Tommy Thompson Park Entrance Development Project

October 18, 2017

Tommy Thompson Park Park Entrance Development Project

Waterfront Toronto Design Review Panel

What We Heard from DRP #2:

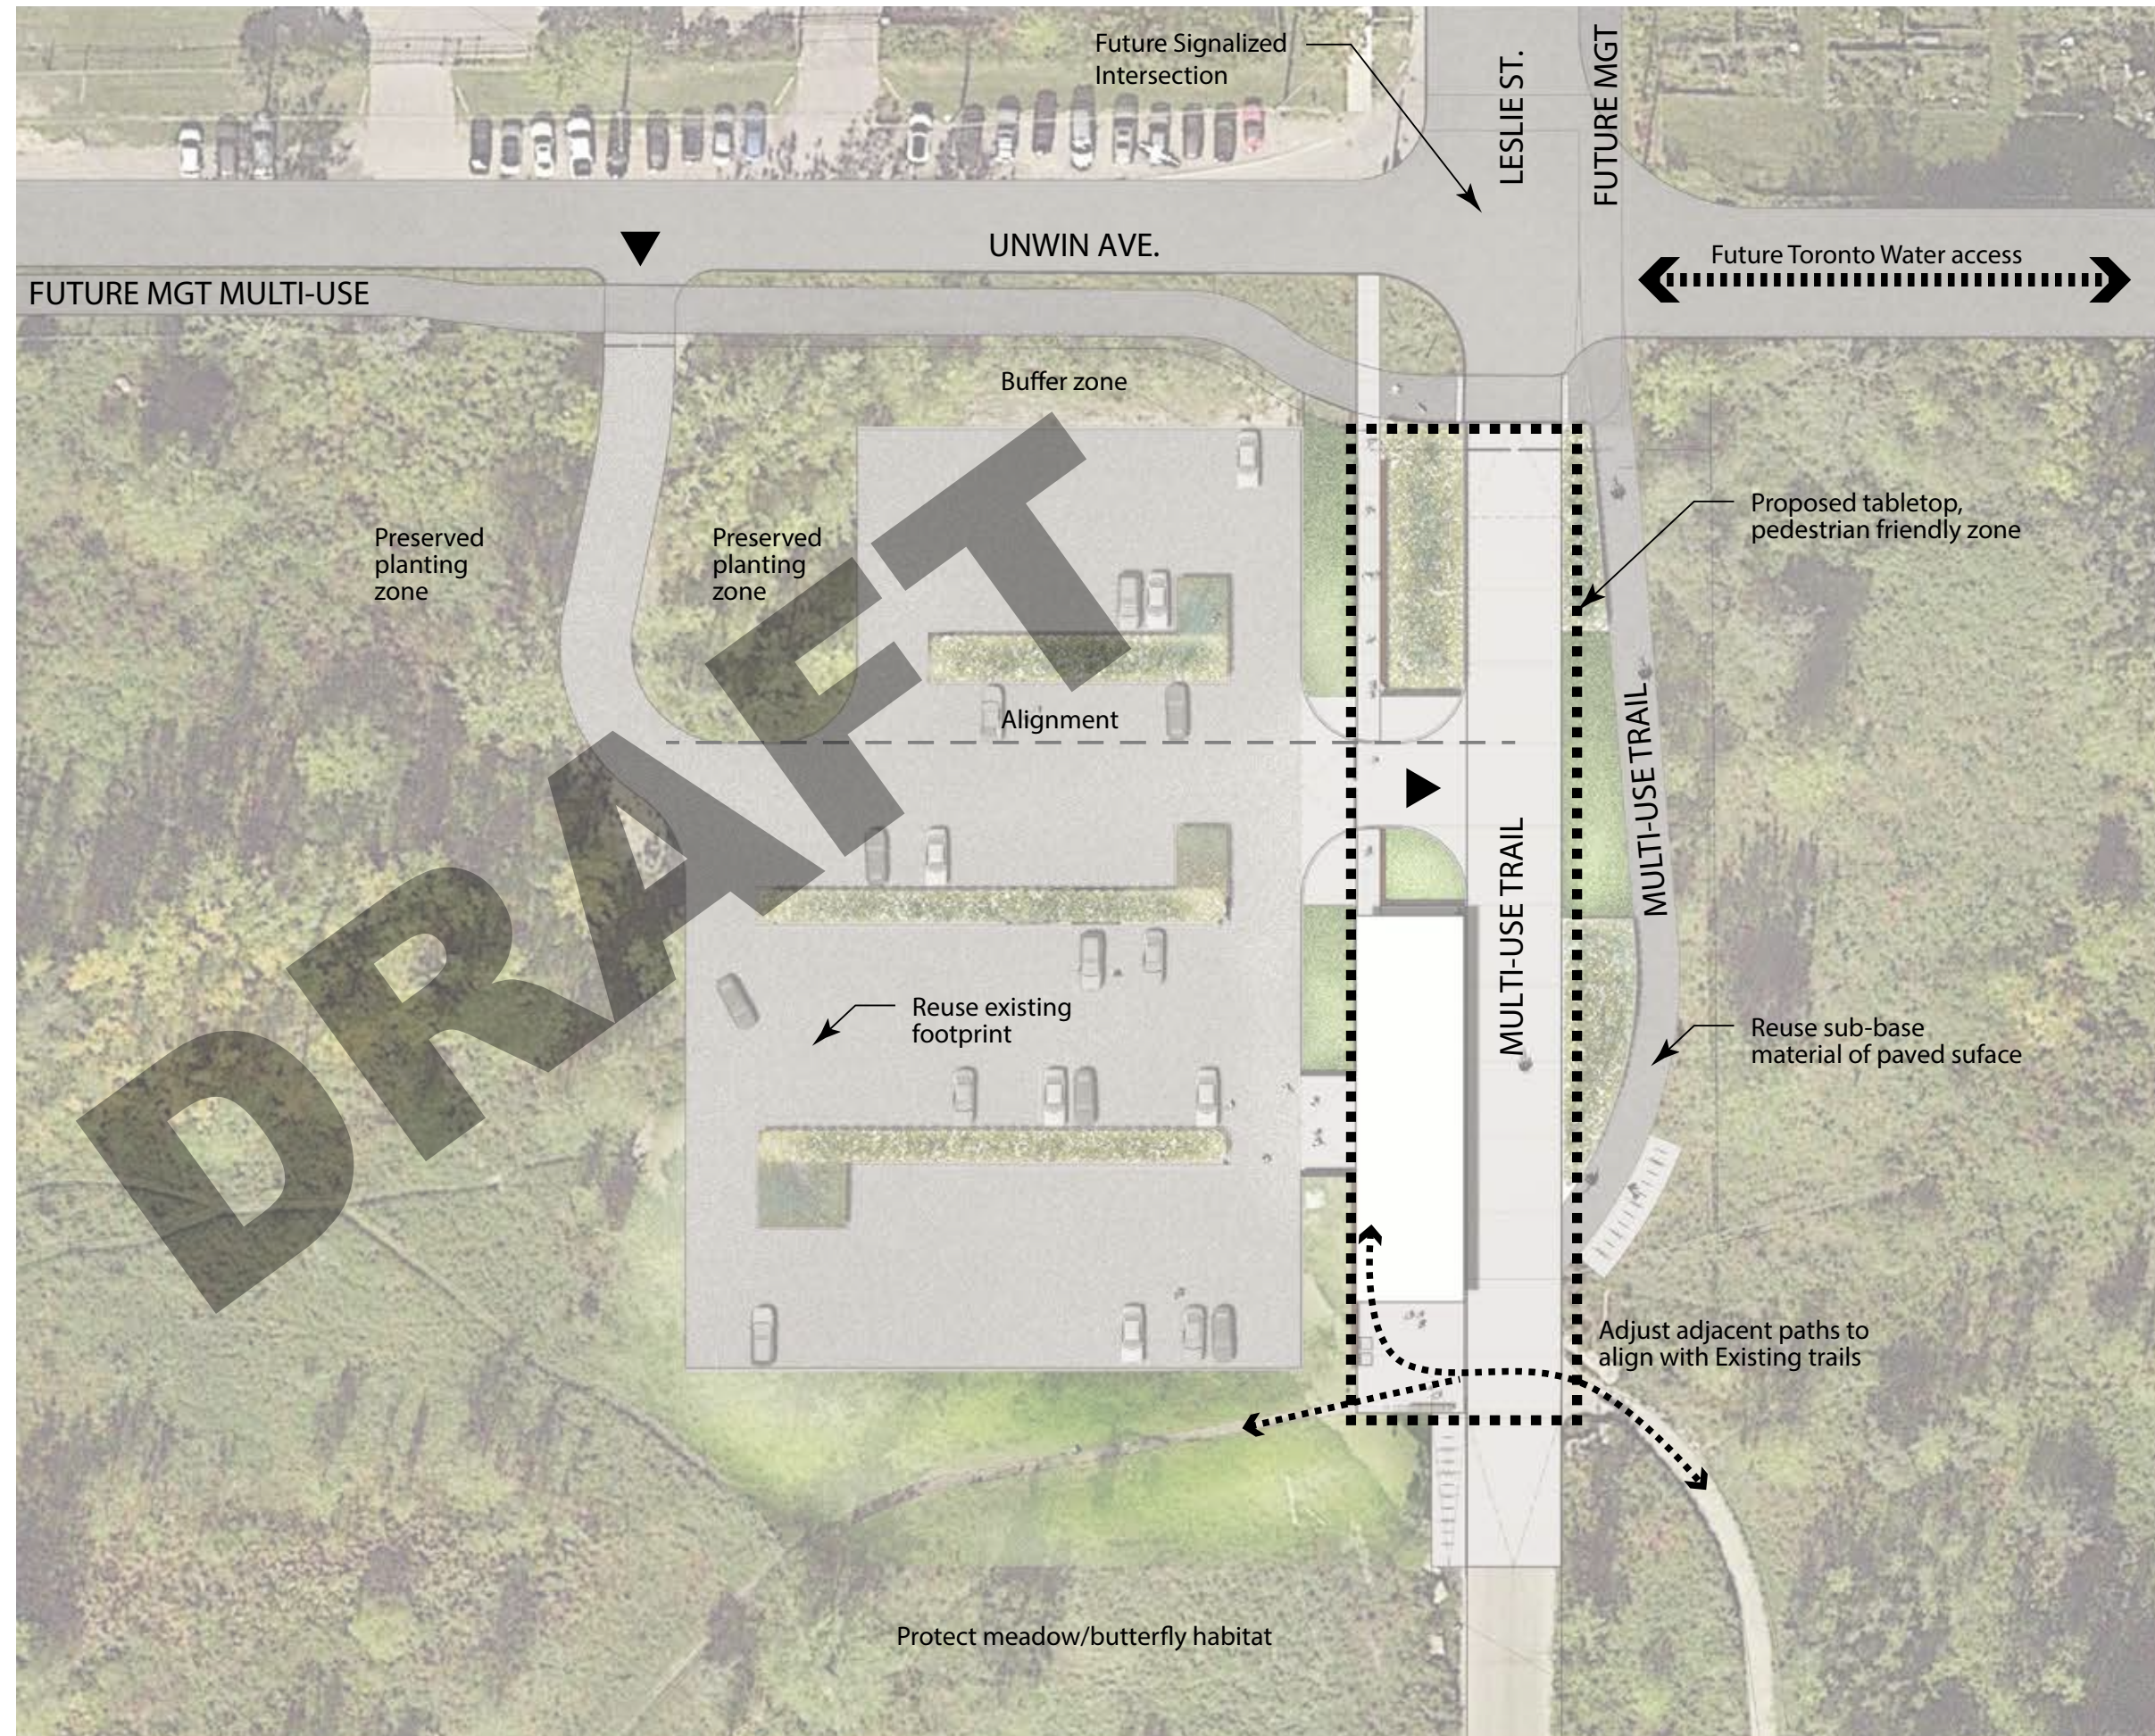
- The landscape design of lush and rough details works well on the site - however the parking lot design needs to be revisited as it still feels suburban.
- The design of the pavilion still feels unresolved and inconsistent with the rough nature of the site. Consider reconceptualizing the pavilion design. Hesitation around phenolic panels for soffit - too smooth and refined.
- Consider using solar domes and solar panels on the roof and adding car charging stations to the parking lot.

- Parking lot has been revised to reduce parking, and to include additional trees in order to break up plan.
- Pavilion roof structure redesigned to cantilever and deepen, disconnected from base and columns removed; windows inset; concrete texture roughened to expose aggregate; inset lettering introduced
- Soffit returned to Cor Ten to relate to other TTP pavilions as directed by WT. Run-off minimized by pre-weathering + soffit orientation and details.
- City of Toronto direction to not introduce skylights or solar panels due to budget, maintenance constraints and durability concerns.

Pavilion Rendering from DRP #1

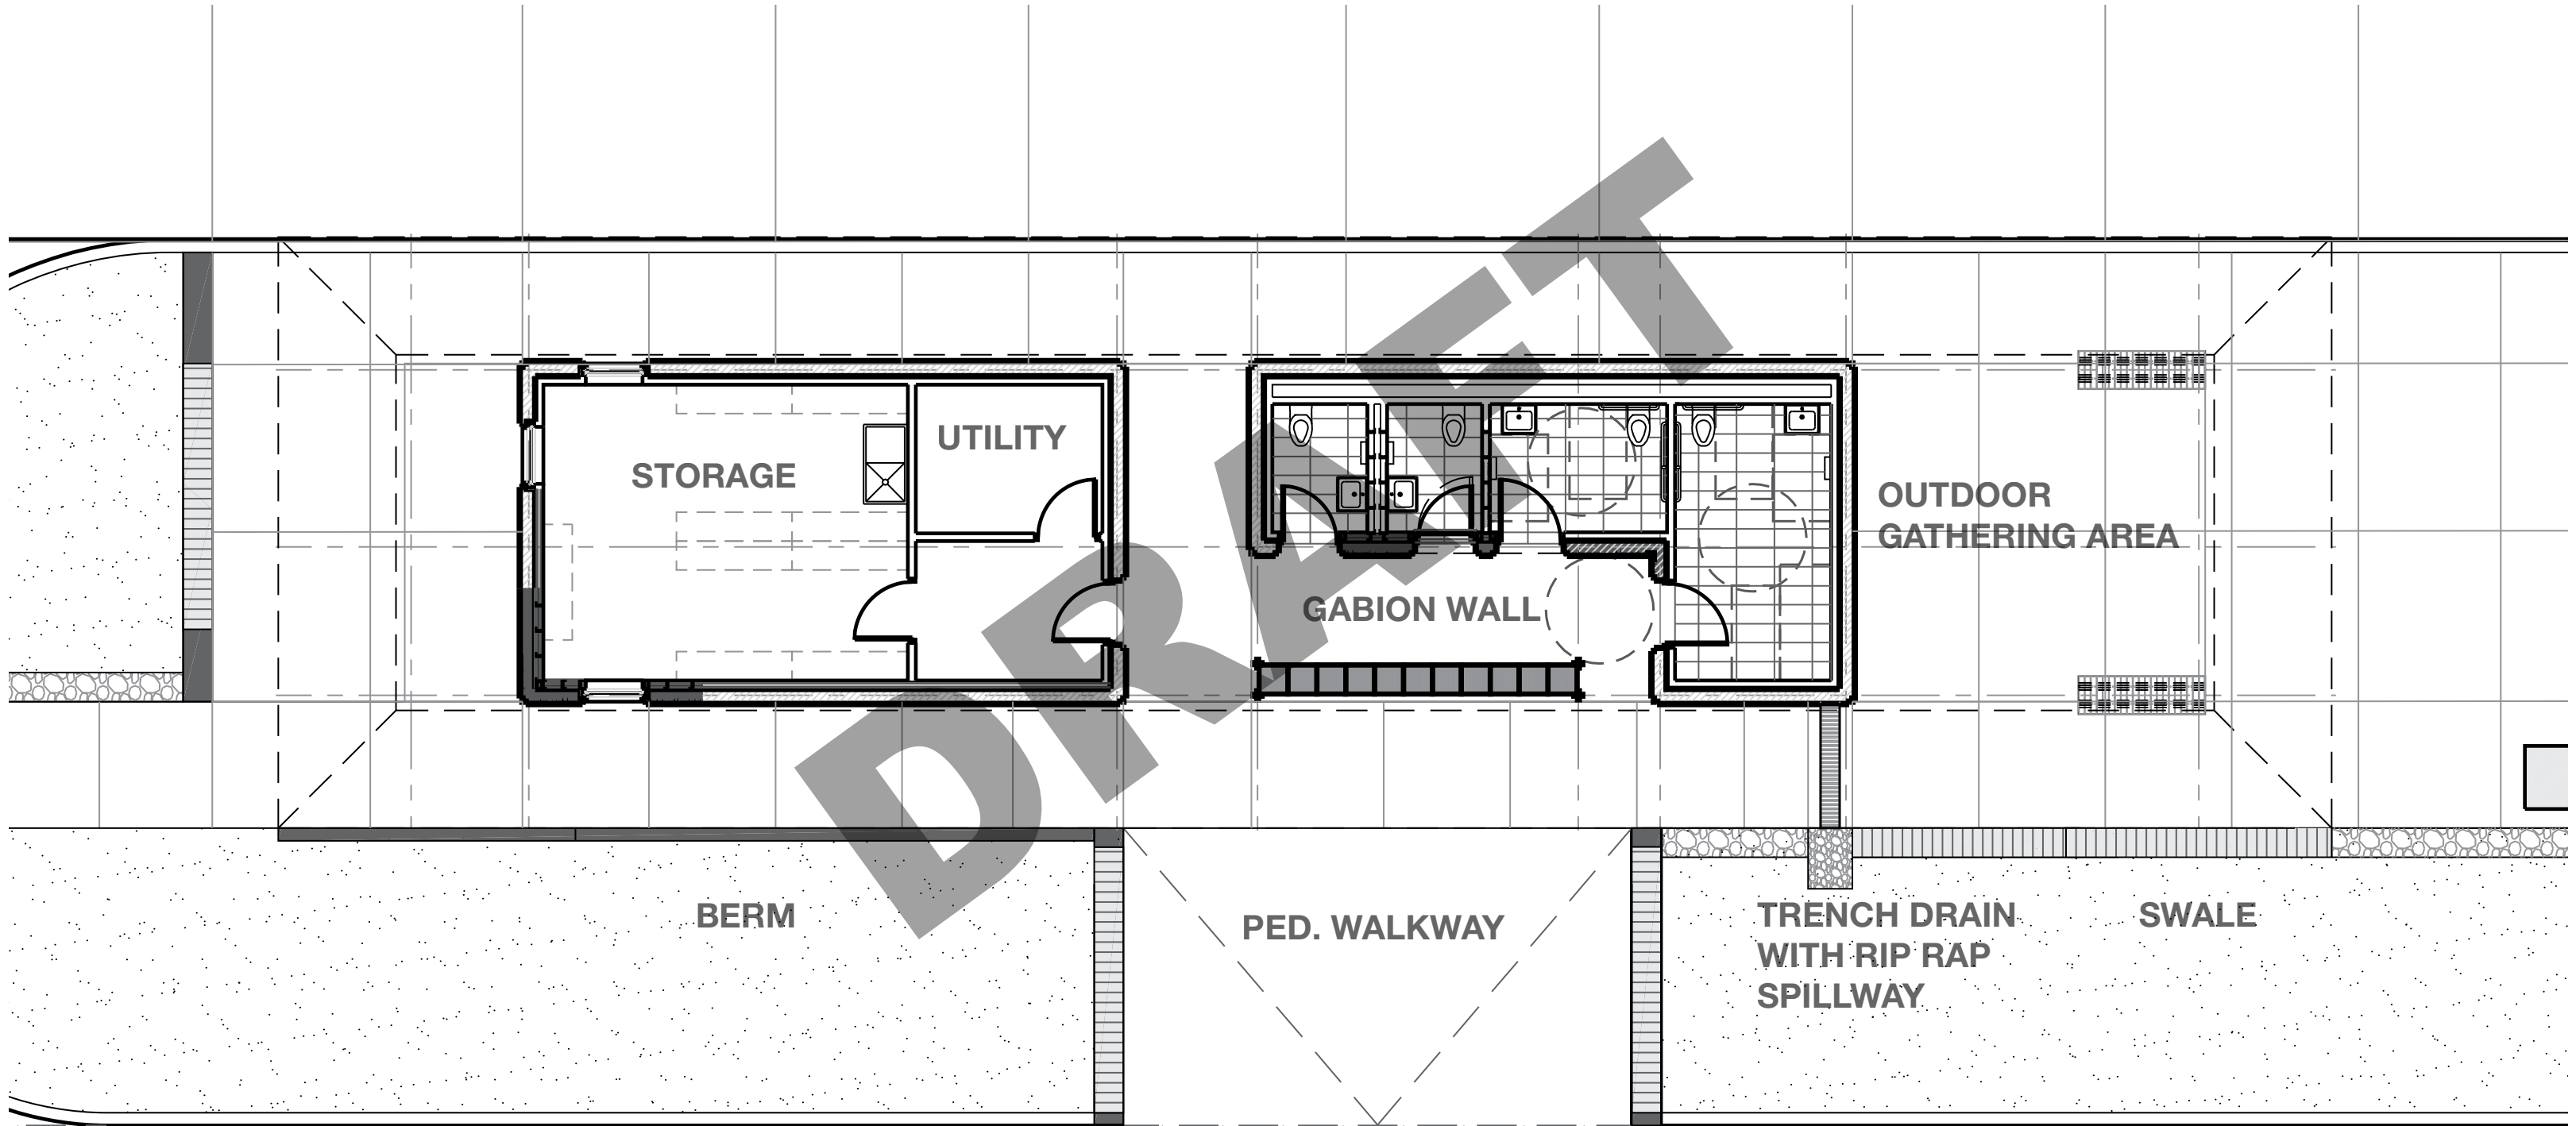
- Gate at entrance - could it be more than an ordinary gate?
- Increase quantity of tree planting (Poplars/ Cottonwoods) in swales / separation of multi use trail from parking.
- Consider using alternative material other than Cor Ten steel on the soffit due to impacts of potential run-off.
- Material selection for pavilion should serve more than a decorative purpose - in relation to gabion wall use in particular.
- Lighting needs to be effective and sensitive.

- City of Toronto direction to use standard park gate due to maintenance and durability concerns
- Additional trees have been added to swales and to perimeter of parking
- Alternate soffit materials investigated - phenolic panel selected and detailed in place of Cor Ten.
- Use of gabion reduced to privacy screening wall at washroom doors.
- Lighting directionality changed to wall wash down instead of up onto soffit. Site lighting is minimal, located adjacent to pavilion and entrance ways to parking and multi-use trail.
